January 19, 2006

RE: Mill Creek Bridge (Br. NO. 1501) Denver Street - Marion Road SE Bridge Replacement, Grading, Paving and Drainage

ADDENDUM NO.2

Date: 12/18/03
 Drawn: J
 Scale: 1"=40'
 Sheet: 4/A

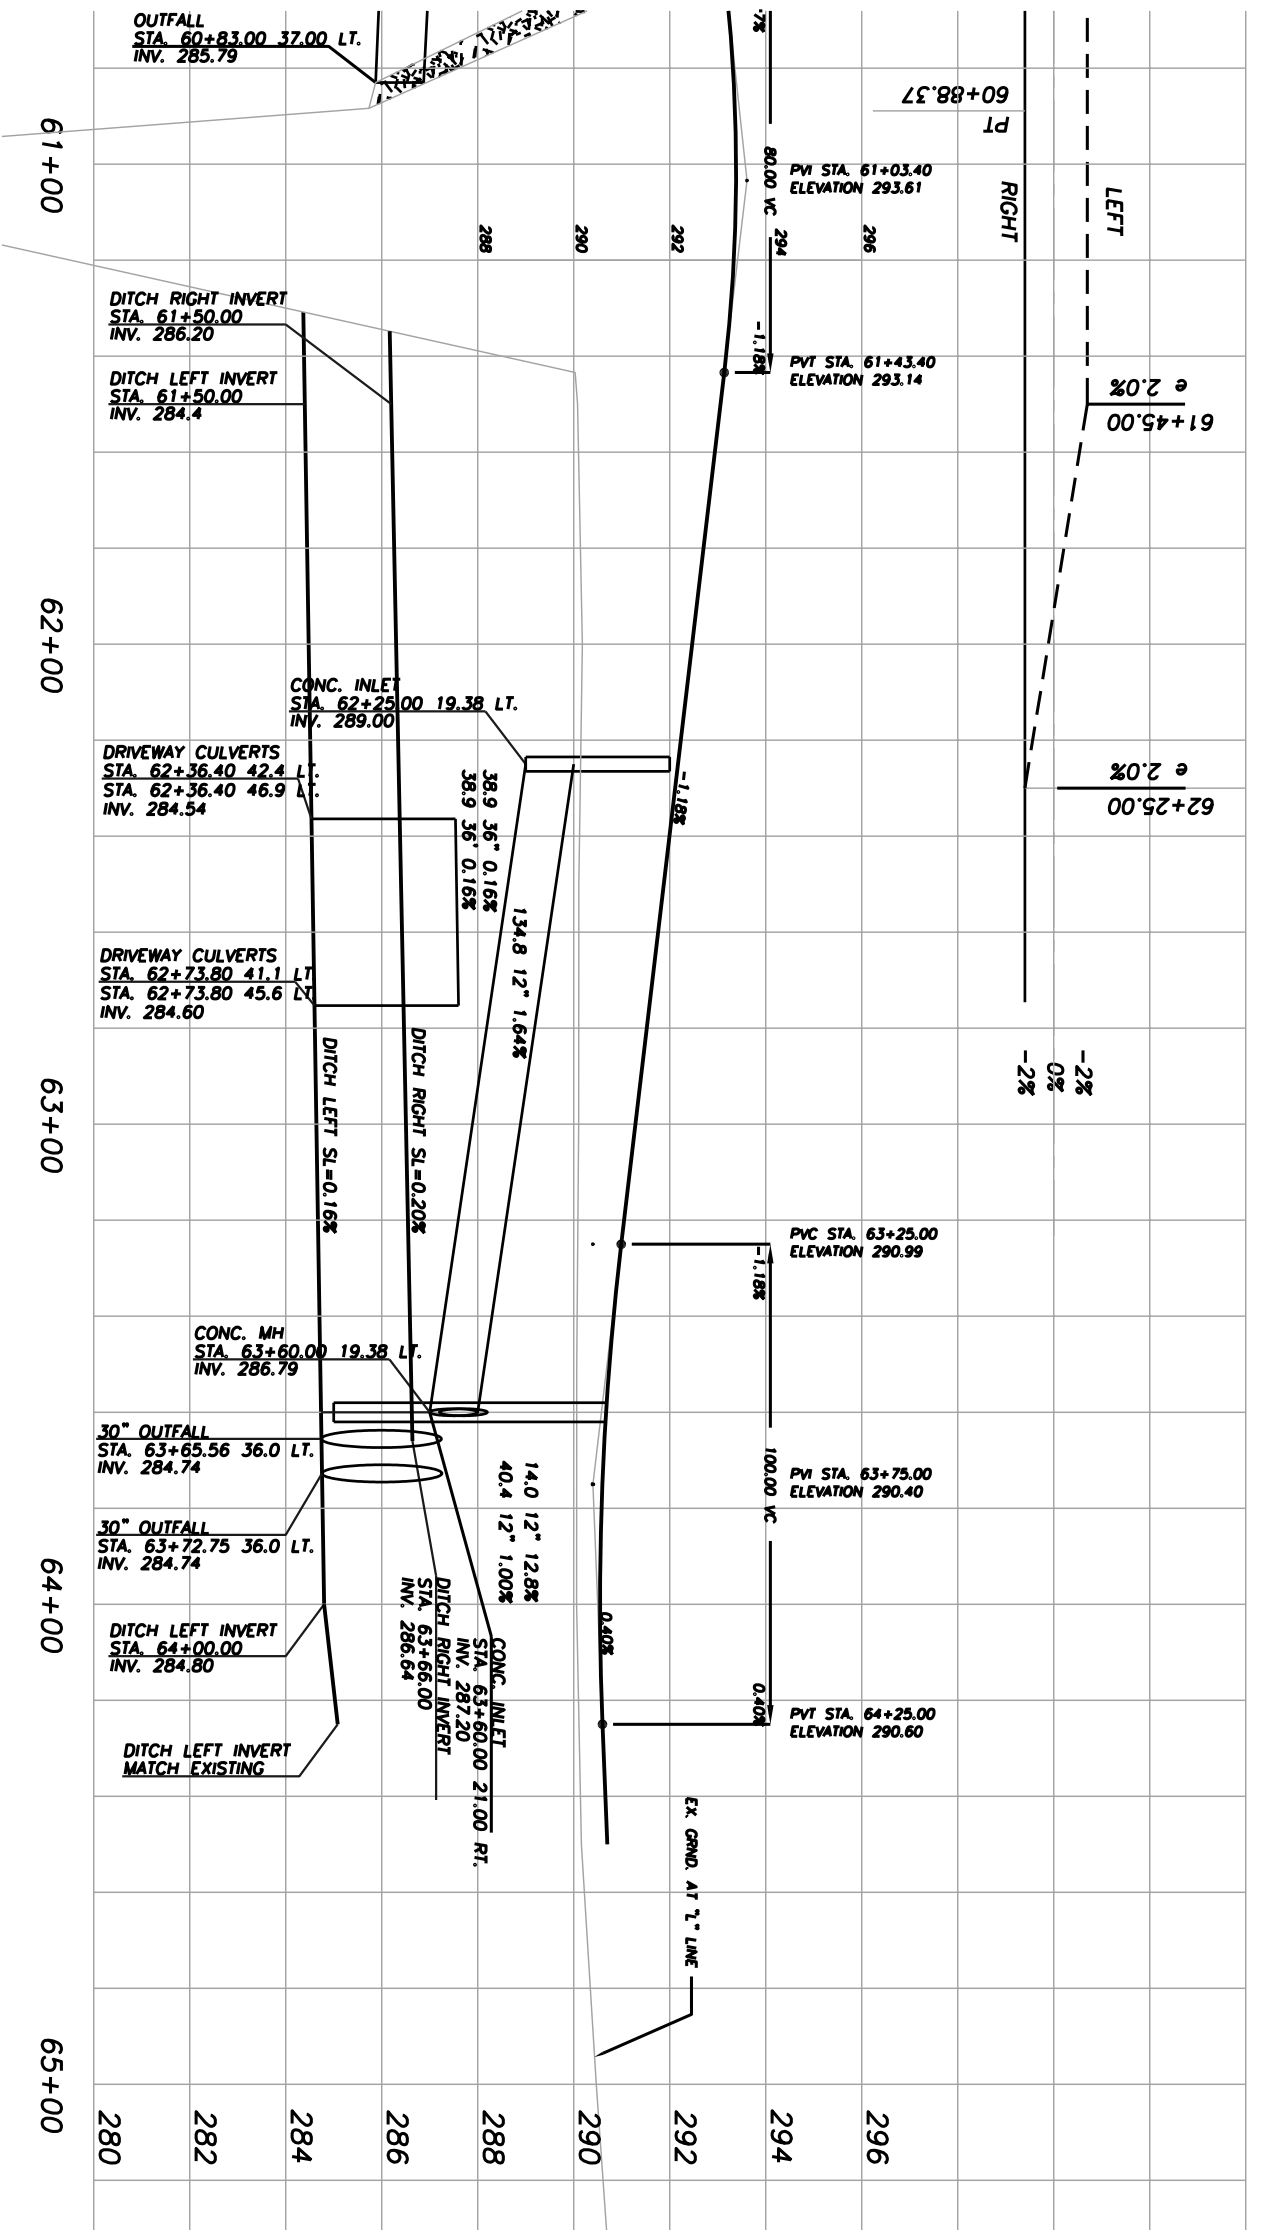
Replace sheets 3, 3B, and 7 with the enclosed sheets. Changes are clouded and include addition of water and sewer line relocation work for the City of Turner and substitution of 36" pipe for 30" pipe in Note 23, sheet 3.

- ㉛ CONNECT DITCH, MATCH EXISTING SECTION
- ㉜ CONSTRUCT ROAD CONNECTION, SEE DETAIL ON SHIT. 2A2
- ㉝ CONSTRUCT DITCH AT TOE OF SLOPE
- ㉞ INSTALL 36" STORM SEWER PIPE - 77.6 TRENCH EXCAV. = 72 CU. YD.

- ㉟ INSTALL 4" DUCTILE IRON FORCE MAIN, SEE HANGER DETAIL ON SHIT. 7 - 231
- ㊱ TRENCH EXCAV. = 43 CU. YD.
- ㊲ INSTALL 10" DUCTILE IRON POTABLE WATER PIPE, SEE BRIDGE HANGER DETAIL ON SHIT. 7 - 116

- ㊳ TRENCH EXCAV. = 11 CU. YD.
- ㊴ CONNECT NEW LINE TO EXISTING
- ㊵ INSTALL J BOX W/ 1 1/2" CONDUIT AND PULL STRING
